DEVIATION REQUEST AND DECISION FORM

Project Name :	Crawford Apartments
Schedule No.(s) :	6513125009
Legal Description :	TRACT A FOUNTAIN VALLEY RANCH SUB FIL NO 6B

A deviation from the standards of or in Section **2.3.7.E.2** of the Engineering Criteria Manual (ECM) is requested.

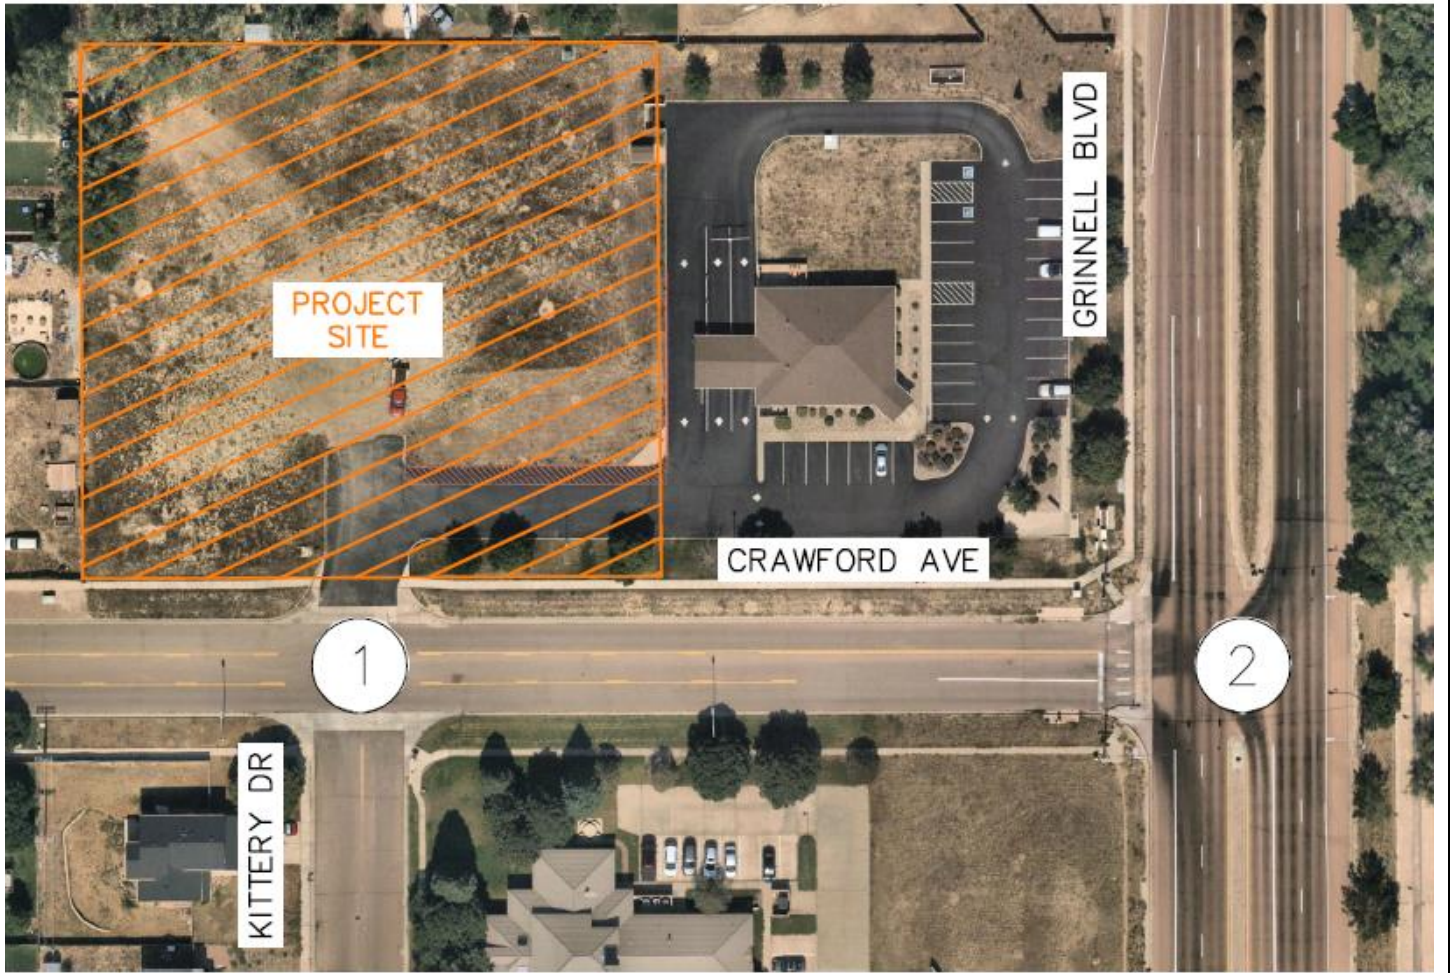
The deviation is requested to provide a substandard left turn lane at the northbound approach of the Crawford Avenue and Grinnell Boulevard intersection (Intersection #2) (see traffic study and image below for reference).

To meet El Paso County standards for a design speed of 55 mph, the recommended northbound left turn lane at the intersection of Crawford Avenue and Grinnell Boulevard should provide 265 feet of deceleration length (ECM Table 2-26) plus 100 feet of storage length (determined from ECM Table 2-30 for each location) plus a 220-foot taper (ECM Table 2-26). Since vehicle queues are only calculated with under 50 feet of storage and to avoid reconstructing the existing raised median for only an additional 65 feet of length, it is recommended that the existing median for the northbound left turn lane at Crawford Avenue and Grinnell Boulevard intersection remain in the current condition of 300 feet with a 220-foot taper.

- 1) Based on the raised median to the south, the northbound left turn lane at the intersection of Crawford Avenue and Grinnell Boulevard should remain at its current length of 300 feet with a 220-foot taper. It should be noted that vehicle queues for the northbound left turn were calculated as 25 feet for the 2023 short term horizon and 35 feet for the 2045 long-term horizon. This would equate to a 290-foot (265' deceleration + 25' queue) and 300-foot (265' deceleration + 35' queue). Please see 95th percentile vehicle queues from the Crawford Apartments Traffic Impact Study for reference.

- 2) The City of Colorado Springs Engineering Criteria Manual (ECM) identifies a left turn lane length of 285 feet plus 200-foot taper length would be needed in this condition. Colorado Springs standards are based on posted speed limits; therefore, based on a speed limit of 50 miles per hour (mph) from Table 3 (Required Deceleration Lane and Taper Lengths) of the COS ECM, a left turn lane length of 235 feet plus a 200-foot taper would be required in this case. Based on footnote of Table 8 (Required Storage Lengths) from the COS ECM, left turn lane storage length shall be based on the 95th percentile queue at signalized intersections. Therefore, as documented above, the 95th percentile queues are 25 feet in the short-term horizon and 34 feet in the long-term horizon; however, COS ECM standards state that the minimum storage length is 50 feet. Therefore, the overall turn lane length required by COS ECM is 285 feet (235 feet of deceleration + 50 feet of storage) plus 200 feet of taper which is currently accommodated in the existing condition.

- 3) The State of Colorado State Highway Access Code (Access Code) identifies a total left turn lane length (deceleration + taper) of 500 feet would be required in this condition. Standards from the Access Code are based on posted speed limits; therefore, based on a speed limit of 50 mph from Table 4-6 (Design Criteria for Acceleration and Deceleration Lanes) of the Access Code, a total left turn deceleration length (taper included) of 500 feet would be required in this condition. The characteristics of Grinnell Boulevard match a NR-B categorization (Non-Rural Arterial with moderate to high traffic volumes) with a speed limit greater than 40 mph which does not require a storage component; therefore, the total lane length of 500 feet is currently accommodated in the existing condition.

This request has been determined to have met the criteria for approval. A deviation from Section 2.3.7.E.2 & 3 of the ECM is hereby granted based on the justification provided.
